**RE: Natomas Town Center East (P18-087)**

WALKSacramento has reviewed the first revised project routing for Natomas Town Center East (P18-087) and we offer the following comments in support of greater walkability within the project and surrounding area.

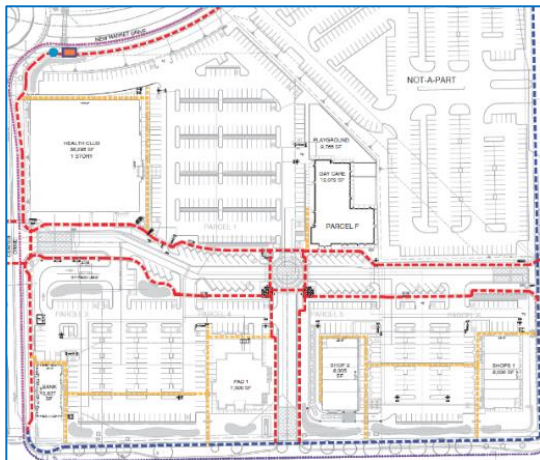
Main Street will be the primary pedestrian and bicycle access to Natomas Town Center East destinations, especially for pedestrians and bicyclists arriving from the surrounding neighborhoods, the education complex to the east, and the community center, aquatics complex and other uses in the North Natomas Regional Park uses to the north. We are pleased to see that the site plan indicates there will be a pedestrian crossing signal at intersection of Via Ingoglia at Main Street. The pedestrian signal will be critical for safety as the intersection, which also includes the driveway into the library parking lot and provides secondary access to the community college campus parking lot. The intersection will not only have significant vehicular traffic, but it will be a desire line for pedestrians walking between the two sides of Via Ingoglia.

Main Street will also be the preferred travel way between the Shopping District and the Civic District for pedestrians and bicyclists. The proposed revision of North Natomas Town Center Design Guidelines retains the guidance in the original PUD design guidelines for the use of wider sidewalks on the "pedestrian spine" (Main Street) with architecture that creates an urban "edge." This is where the current development effort should focus, rather than fronting Main Street with primarily parking lots and Del Paso Road with buildings and parking.

To activate Main Street with pedestrian destinations that will also serve visitors and patrons arriving by car, Shops 1 and Shops 2 should be moved to the south edge of Main Street with their parking fields between the buildings and Del Paso Road. Pedestrian access to the buildings would be greatly improved, while visibility from Del Paso Road would be retained. Future densification of the project site could then occur along Del Paso Road. The Day Care building fronts Main Street with the pedestrian entrance and a wide sidewalk on Main Street, but the Health Club doesn't engage the street and has its entrance facing the parking lot on the side. The buildings to the south side of Main Street should see much greater pedestrian activity, so the sidewalks on the south side of Main Street should be widened to 16', matching the sidewalk minimum width along the pedestrian spine in the Shopping District. **Recommendation #1: Move the Shops 1 and Shops 2 buildings to Main Street and increase the sidewalk width to 16'.**

Rev 1 Circulation

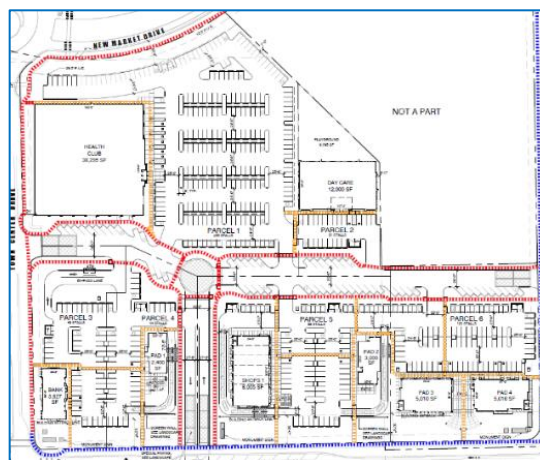
The proposed site plan (Rev 1) provides pedestrian access to Shops 1 and Shops 2 primarily from Del Paso Road, and to Pad 1 from the Del Paso Road driveway. Overall, the site has three connections from Del Paso Road, one from Main Street utilizing the driveway sidewalk and one from Via Ingoglia, for a total of five connections. It will be beneficial to provide connections from Del Paso Road as the pedestrian environment is undesirable due to the high traffic speeds and volume, but it would be better to provide superior internal circulation that's connected to the corners at Town Center Drive and Via Ingoglia. This would allow pedestrians to avoid the roadway noise while providing access to the buildings.

The original plan provided a total of nine connections – four from Del Paso Road, four from Main Street, one of which utilized the driveway sidewalk, and one from Via Ingoglia – the primary difference being that convenient access from Main Street was provided. An extract from the Rev1 routing *Pedestrian Access Town Center East* drawing and an extract from the original routing *Proposed Site Plan* drawing with pedestrian paths indicated using similar color coding are shown below for comparison.

The Rev 1 site plan eliminated the two buildings (Pad 3 and Pad 4) in the southeast corner of the site. These two buildings, although they faced the parking lot behind them, had a good relationship to Del Paso Road created by the patio between the buildings extending towards the street plus the proximity to Via Ingoglia. The arrangement and street relationship of the original proposal for Pads 3 and 4 are similar to the existing Pad A and Shops G buildings in the southeast corner of the existing Shopping District (North Natomas Town Center West). Main Street could be better activated and pedestrian oriented if the building and hardscape design for the original Pad 3 and Pad 4 buildings were rotated 180° and moved to the south side of Main Street.

**Recommendation #2: Orient Shops 1 and Shops 2 to face Main Street with a shared plaza between the buildings, similar to Pads 3 and Pads 4 in the original routing.**
